CD-2023-264

**Subject: Federal Cell Facility Application: Responses to the Director's Request for Information –
DRC-2023-078530**

Appendix B: Federal I Cell Facility Engineering Drawings

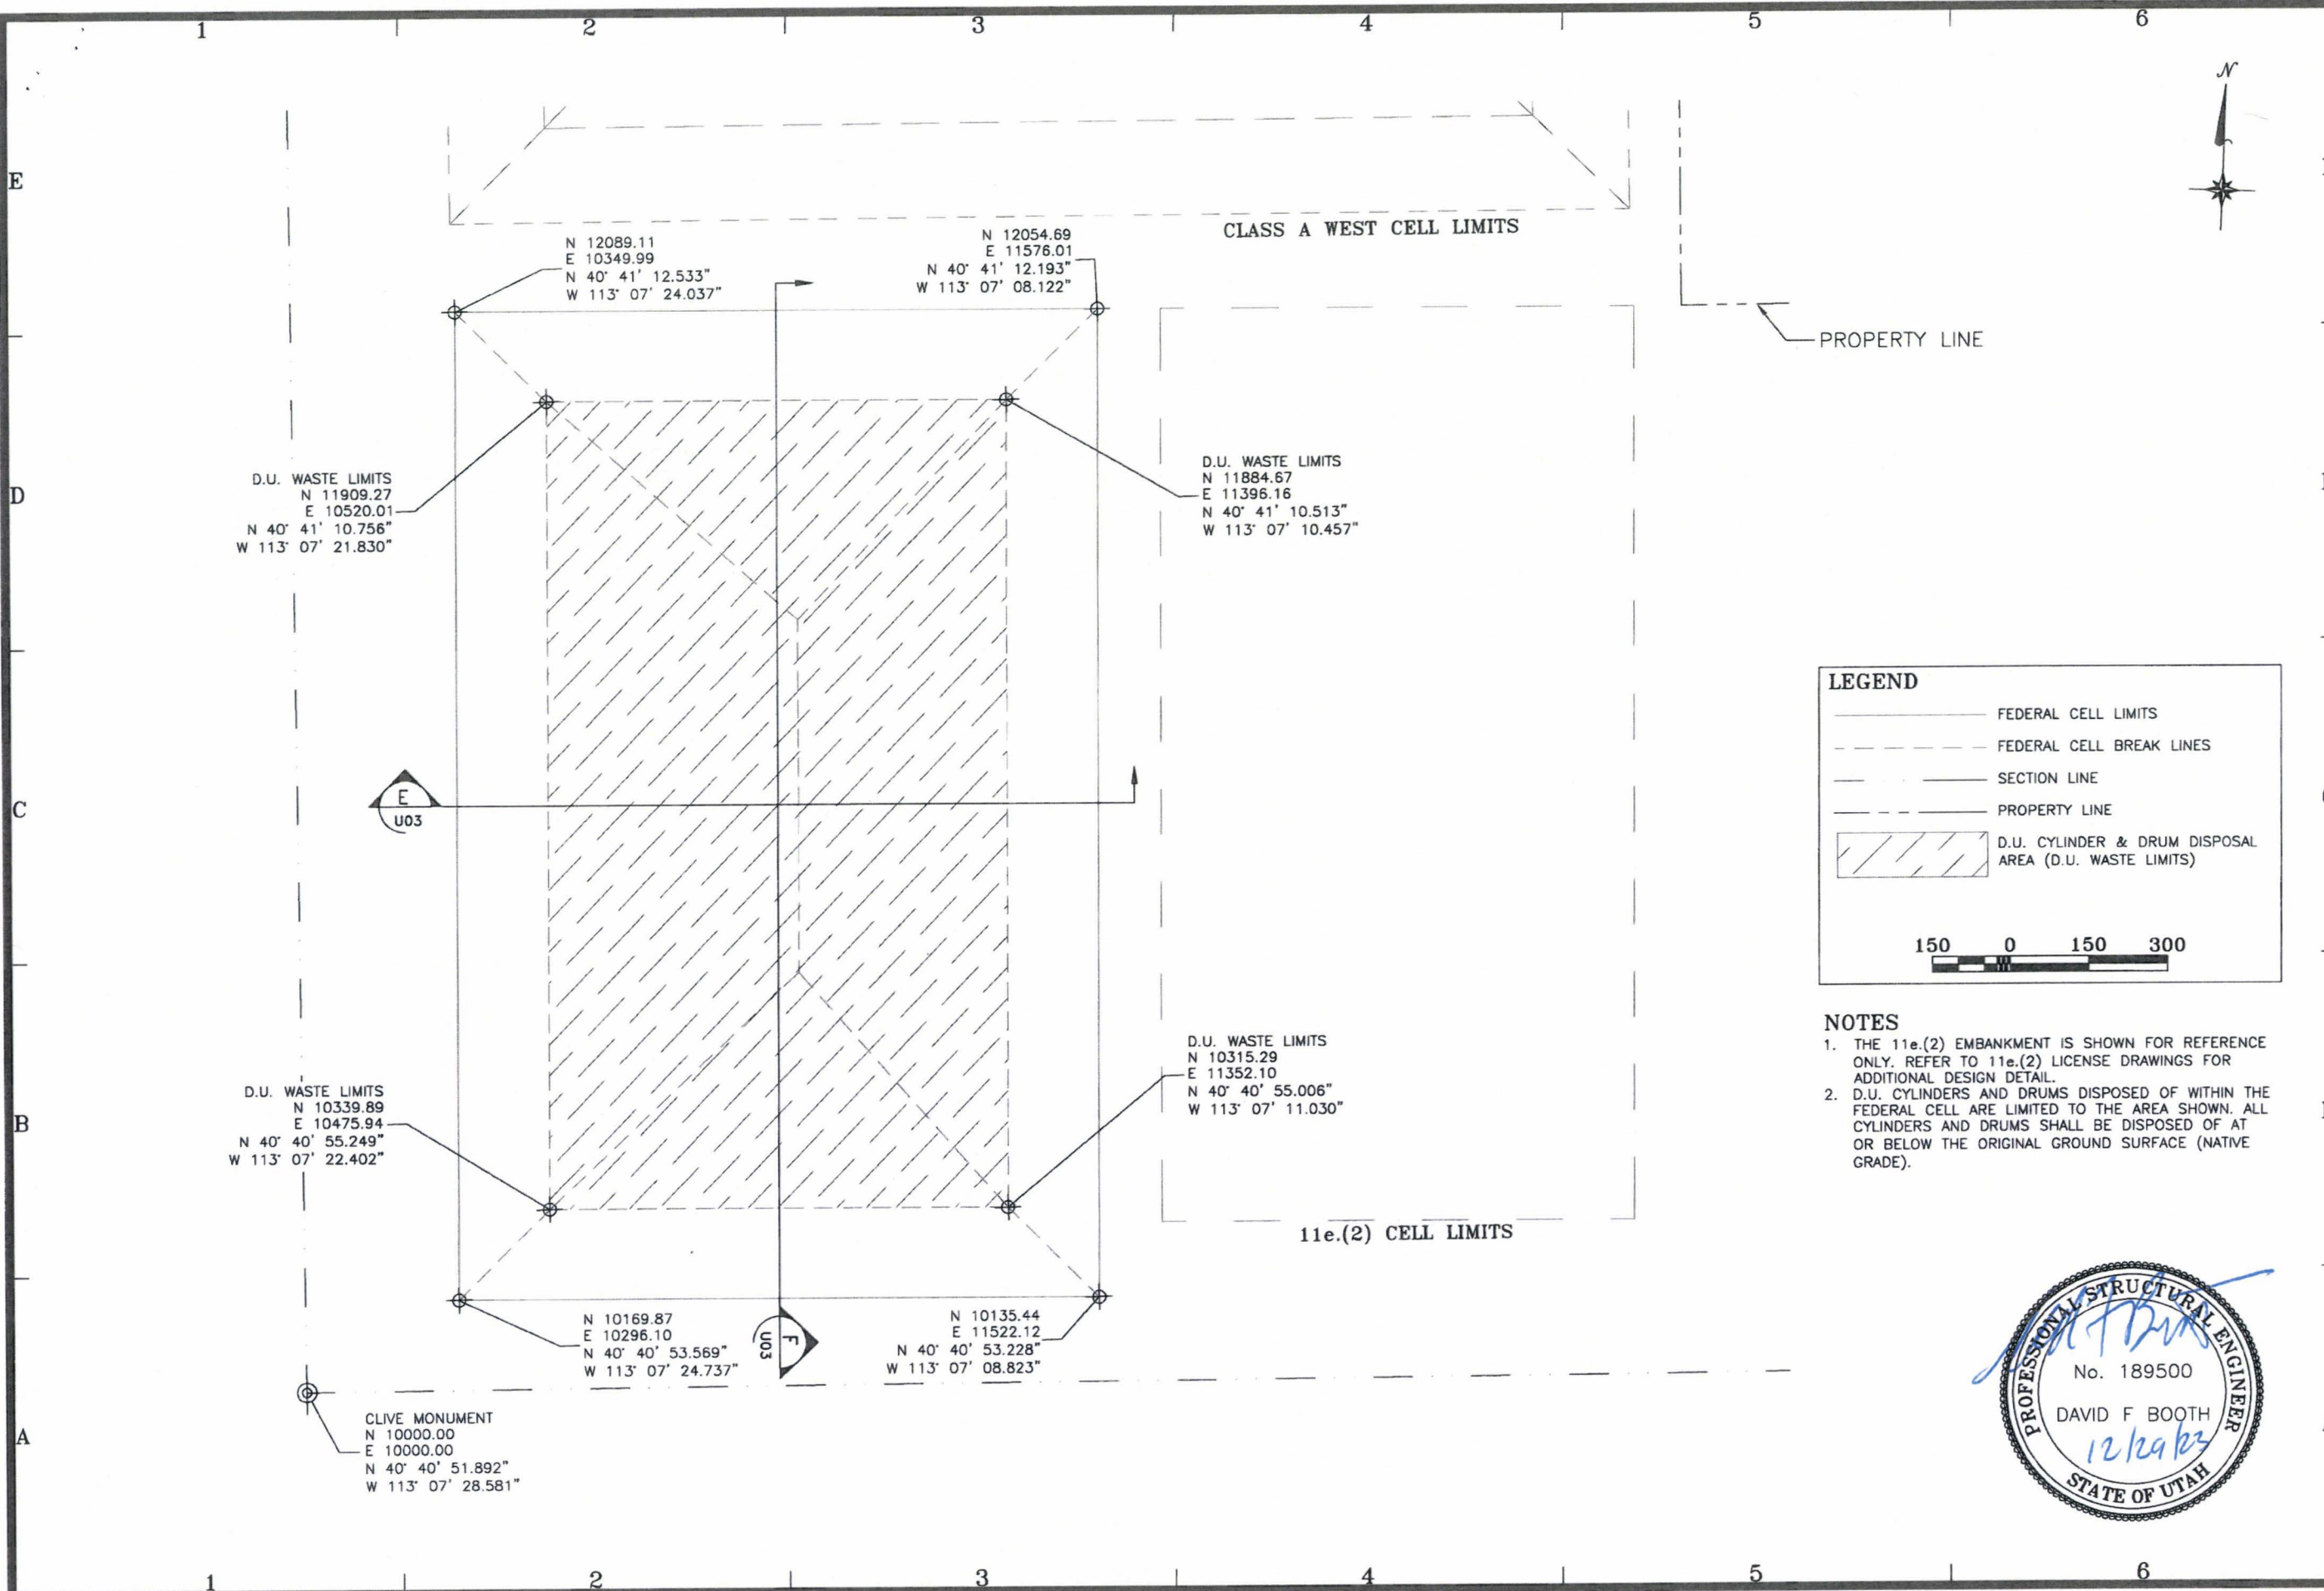
B-47: *Linework is not noted in the Legend or called out on the plan.*

Linework has been added to the legends on Engineering Drawings 14004-L01 and 14004-U01.

DESIGNED BY	D. BOOTH
REVIEWED BY	N. CLARKE
APPROVED BY	D. BOOTH
DATE AS SHOWN	01/14/20
SCALE	AS SHOWN
PROJECT NO.	14004 U02

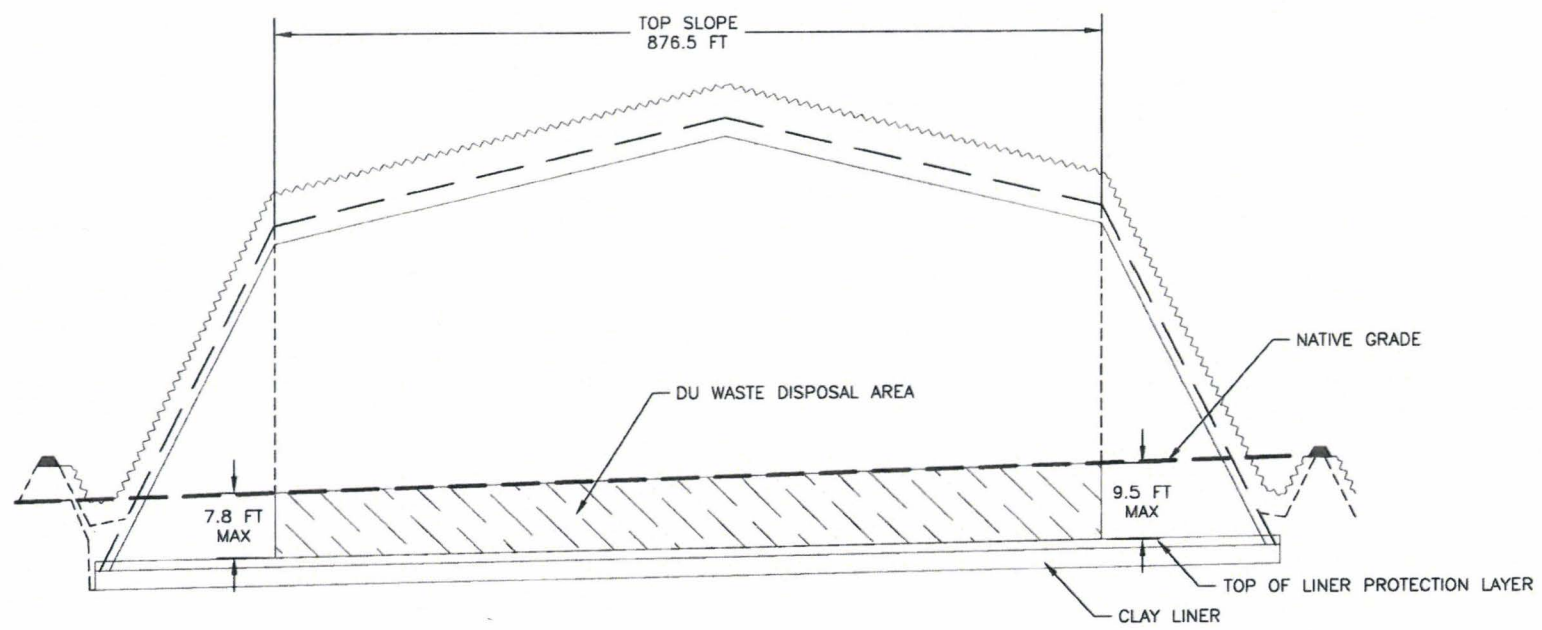
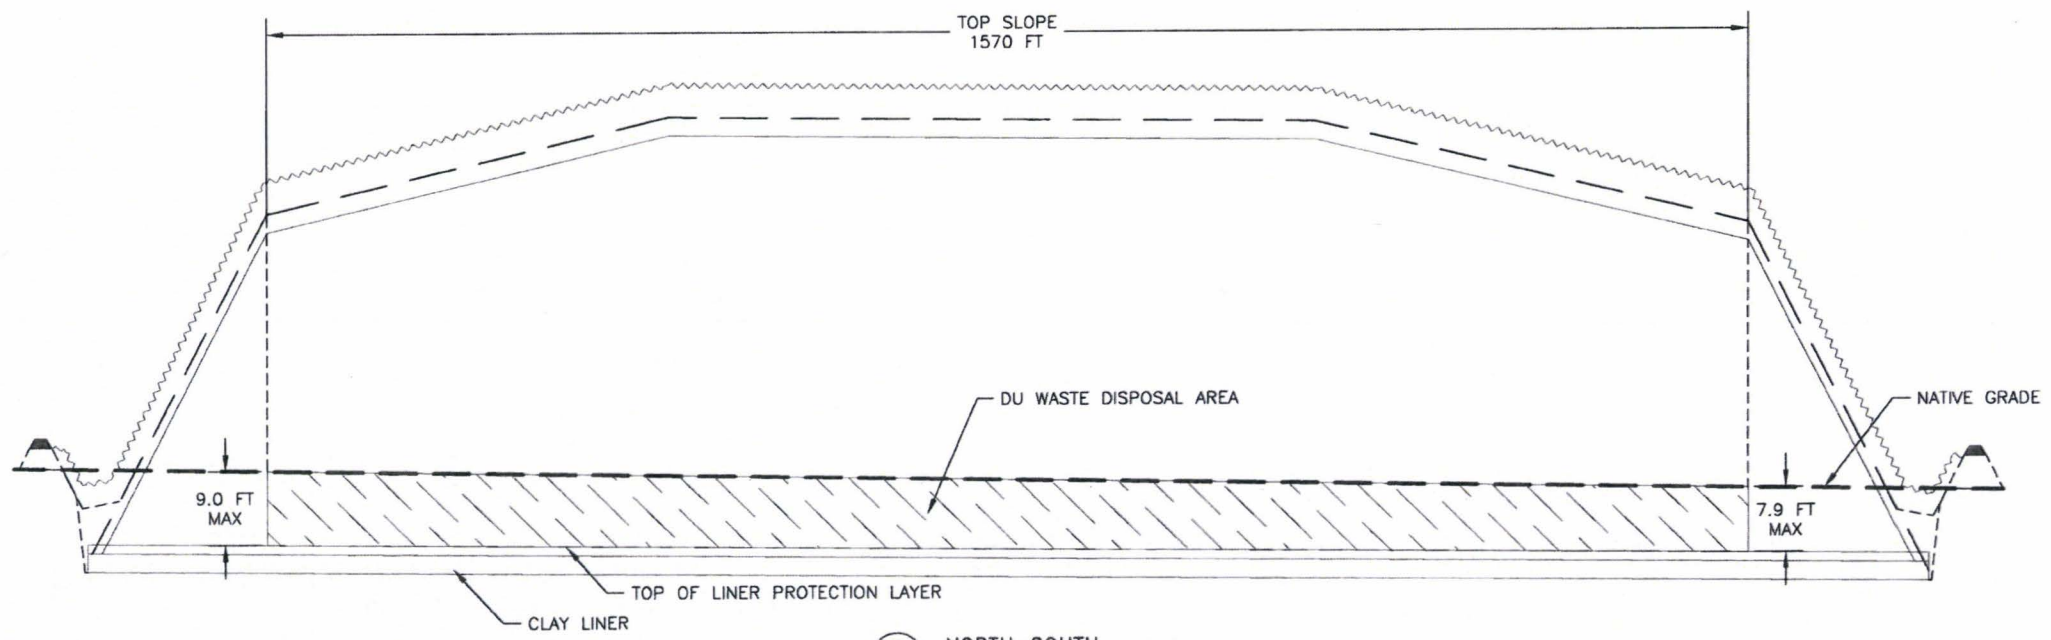
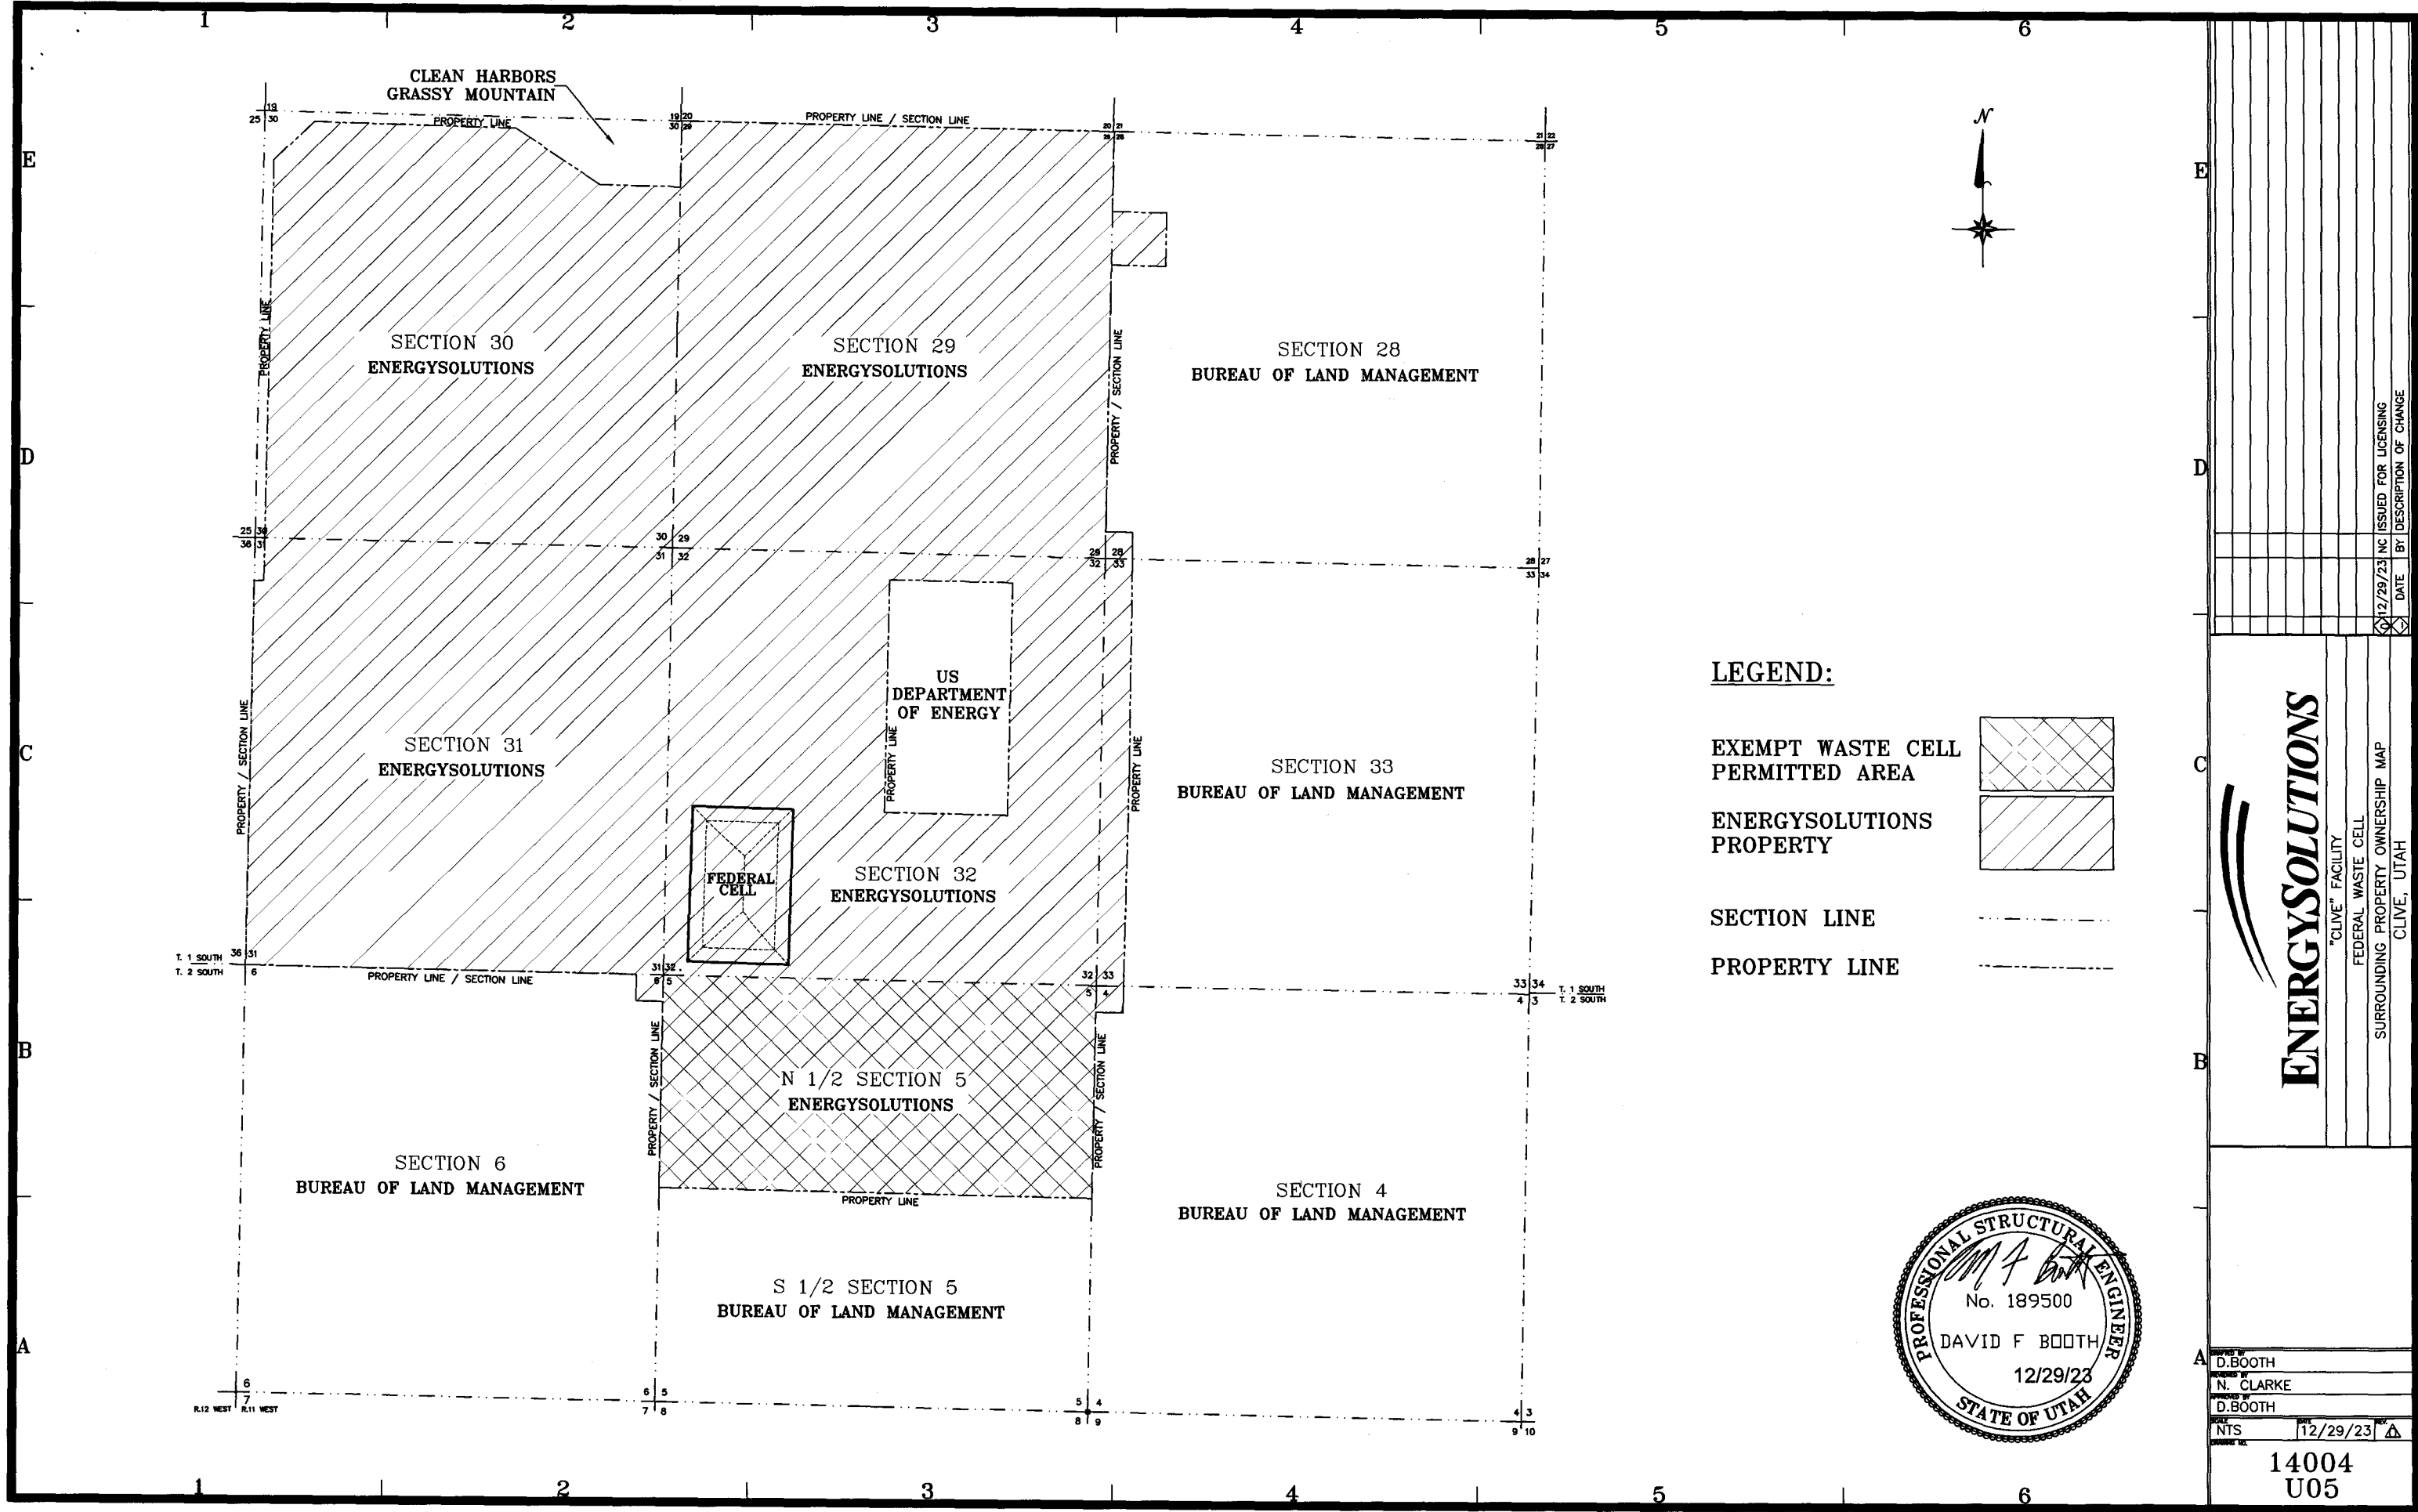
B-52: It is unclear why these dimensions are approximated, and lack of dimensional call outs exists within these cross sections. These dimensions must indicate minimum/maximum dimensions to satisfy minimum/maximum design requirements as stated within the text of the Application and Appendices. Ambiguity within these dimensions can lead to misinterpretations of the limits of Depleted Uranium. Additionally, please provide clarifications of the dimensions and vertical offsets.

The dimensional precision has been unified and expanded on Engineering Drawing 14004-U02.
